AMENDMENT OF SOLICITATION/CONTRACT (AGREEMENT)

Solicitation #AAFES-REZC-04-005-09-079
Attachment #1 to
Amendment #1

QUESTIONS AND ANSWERS

PROJECT:	
AAFES GAS STATION	
CREECH AFB	NEVADA
DRAWING TITLE:	MISCELLANEOUS SITE DETAILS
DATE:	SCALE:
JAN 13 2009	AS NOTED
DRAWING/PROJECT NO.:	SHEET:
4662-06-000007	C5.0

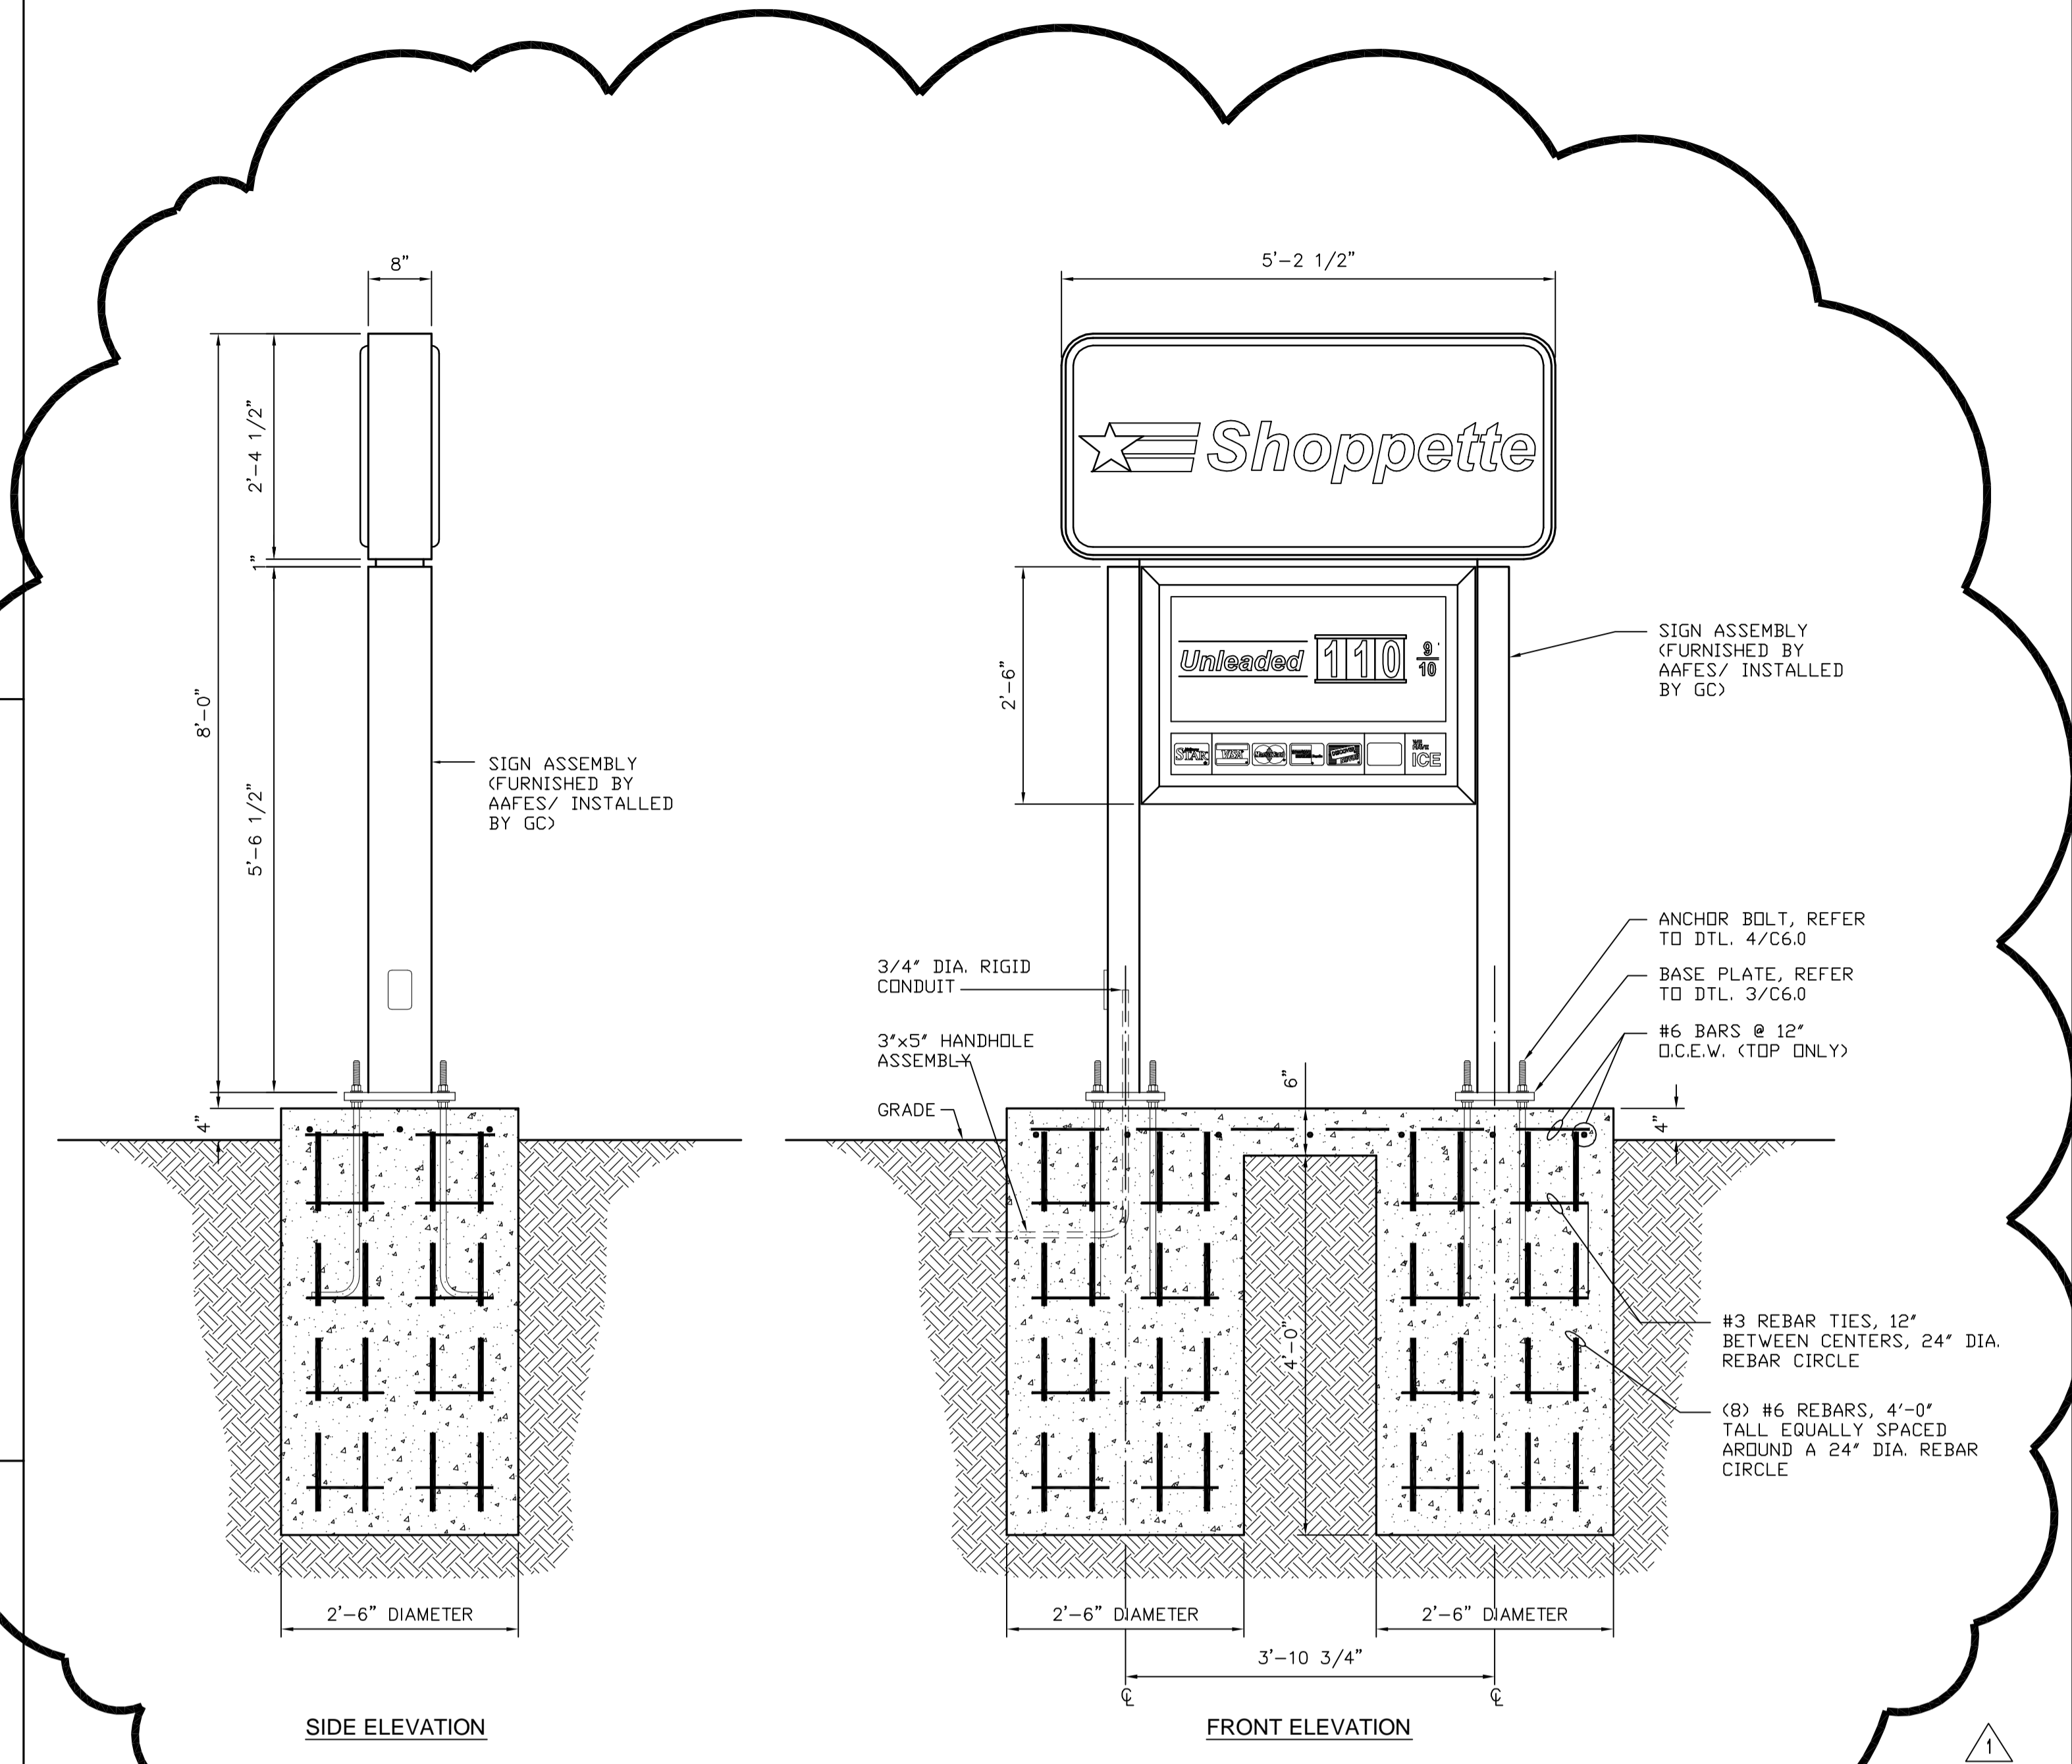
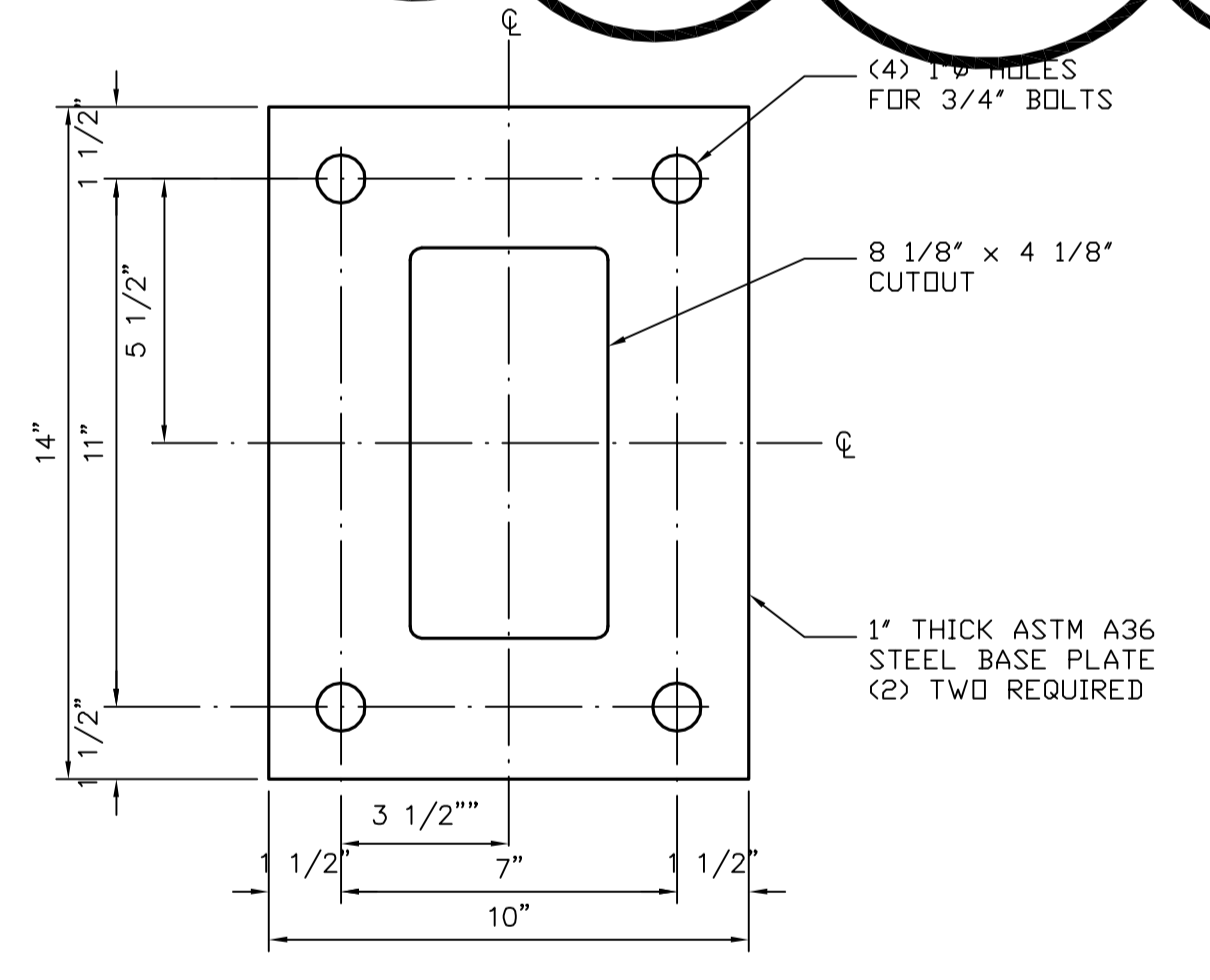
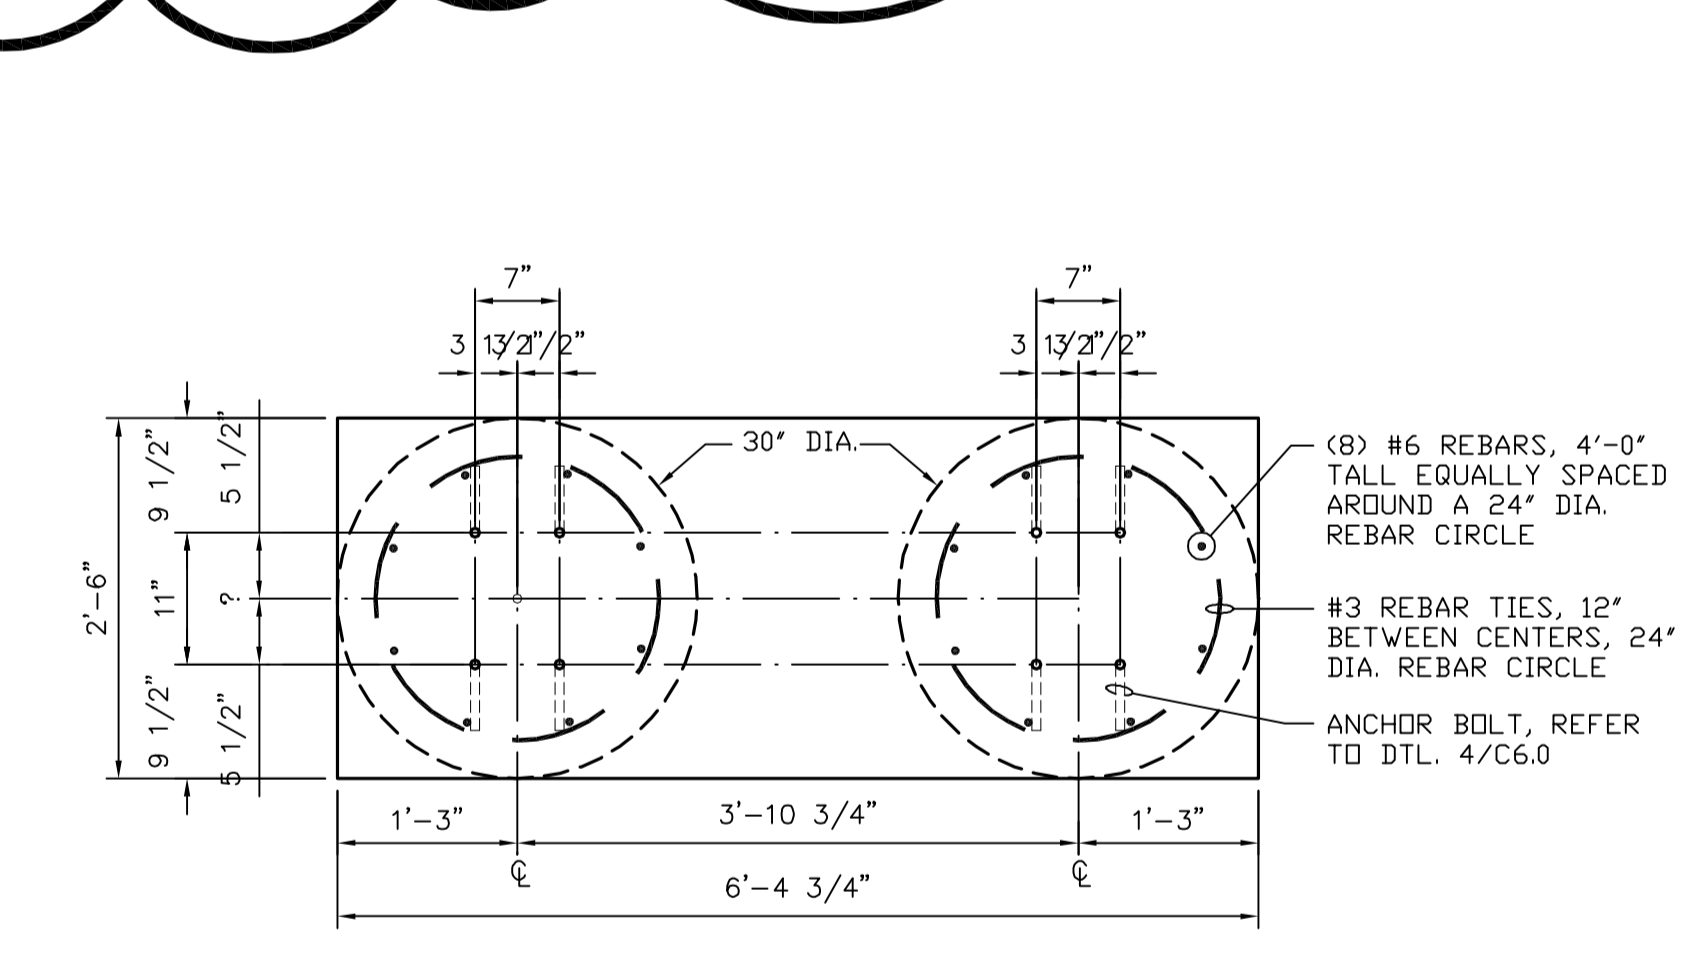
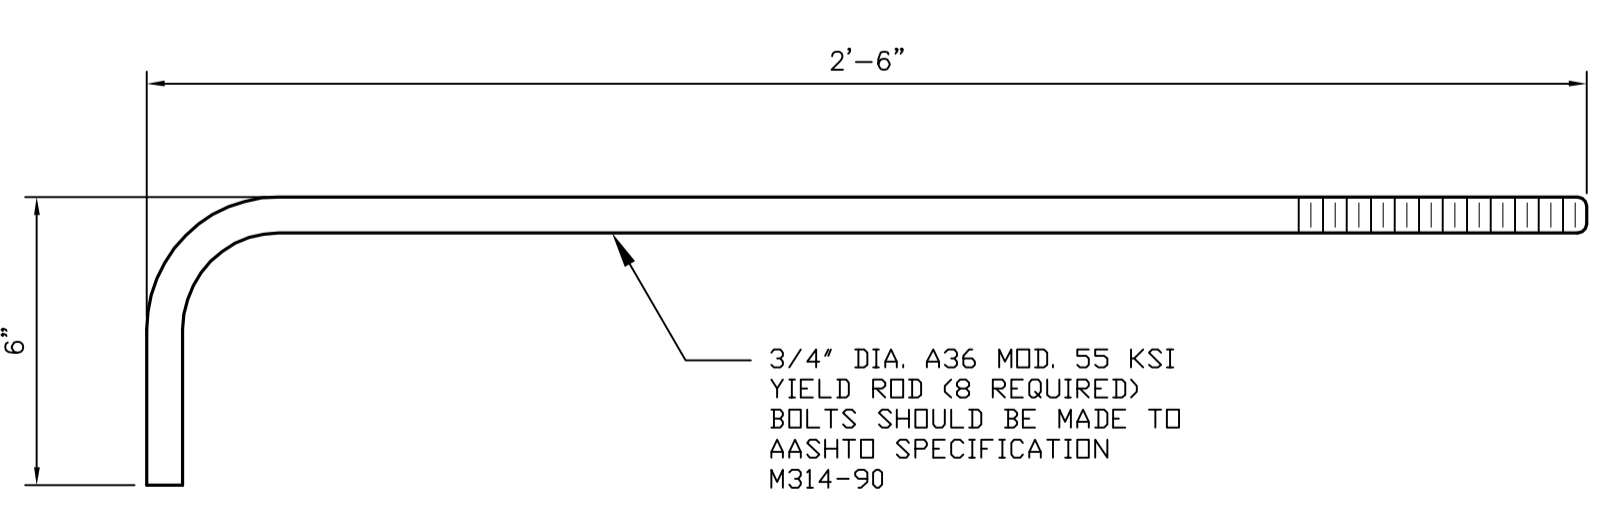
QUESTION 1: Regarding the monument sign. Is this monument sign AAFES supplied? 2 different sign manufacturers have stated that on previous projects the monument signs were supplied by AAFES and installed by the GC. If this monument sign is to be GC supplied and installed, much greater details including engineering will be needed for the sign contractors to supply bids. No specification section is provided for the monument sign.

ANSWER 1: Contractor will be responsible for installing the footings and anchor bolts. AAFES will furnish the sign for contractor to install and hook up. Delete Drawing C5.0 dated Jan 13, 2009, and substitute attached Drawing C5.0 dated 24 Sept 09.
